VIRGINIA ELECTRIC AND POWER COMPANY
NORTH ANNA POWER STATION UNITS 1 AND 2
PROPOSED TECHNICAL SPECIFICATIONS CHANGES
ELIMINATION OF SEISMIC EFFECTS FROM CONTROL ROD DROP TIMES
REQUEST FOR ADDITIONAL INFORMATION

Response to Request for Additional Information
Elimination of Seismic Effects from Control Rod Drop Times

Figure 2.2

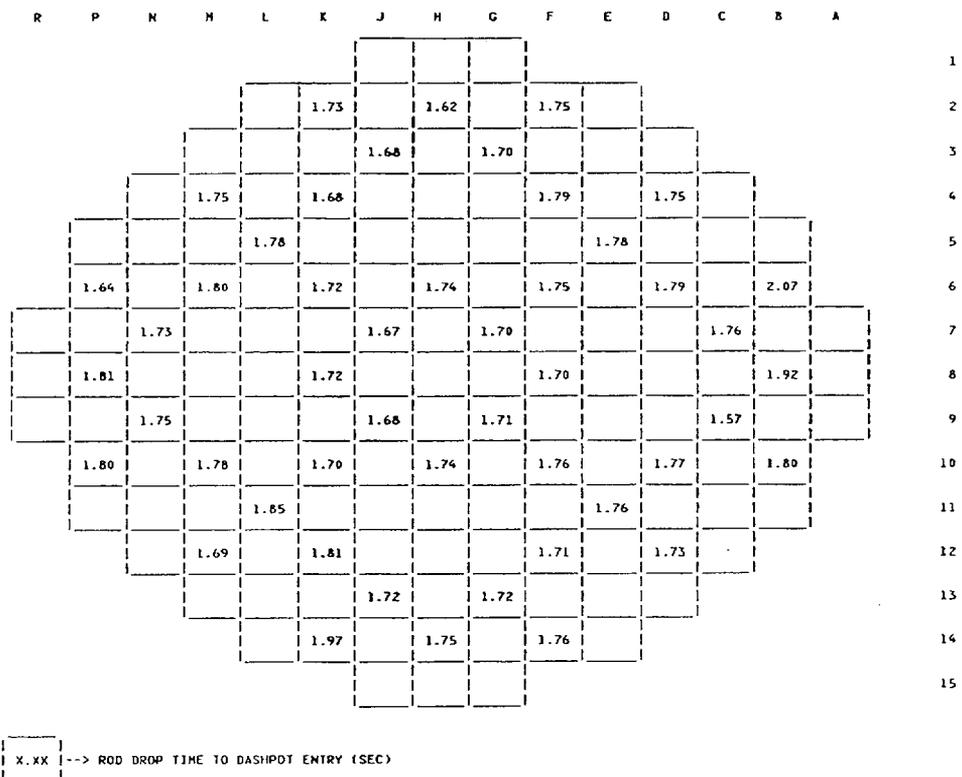
The submittal dated June 22, 2000 indicated that if accident analyses are re-performed, the rod drop time of 2.7 seconds would need to be increased. Such a change would involve concurrent reactor protection system changes (e.g., reductions in high pressurizer pressure and/or low RCS flow reactor trip setpoints). The submittal indicated this would have the potential to reduce normal operating margin and increase the potential for reactor trip events and associated plant equipment transients. Please discuss the potential magnitude of the decreases in the setpoints.

Our evaluation of the effects of using a full core of advanced fuel products (with their associated higher pressure drop and reduced thimble tube ID) concludes that measured rod drop times could potentially increase by as much as 0.5 seconds at North Anna. This increase results from the fact that advanced fuel assemblies have a higher hydraulic resistance and core pressure drop than current generation fuel. This higher pressure drop forces more flow up the RCCA guide tubes, creating more resistance to control rod insertion and, therefore, slightly delayed drop times. The seismic effect amplifies the magnitude of the estimated drop time increase.

Current measured drop times provide slightly in excess of 0.5 second of margin to the 2.7 seconds Technical Specification limit (see attached Figure). However, much of this margin is currently allocated for the seismic allowance.

If the seismic penalty is not eliminated, Dominion estimates that the safety analysis rod drop time will have to be increased from 2.7 seconds to 3.2 seconds to ensure adequate margins for BOC startup tests.
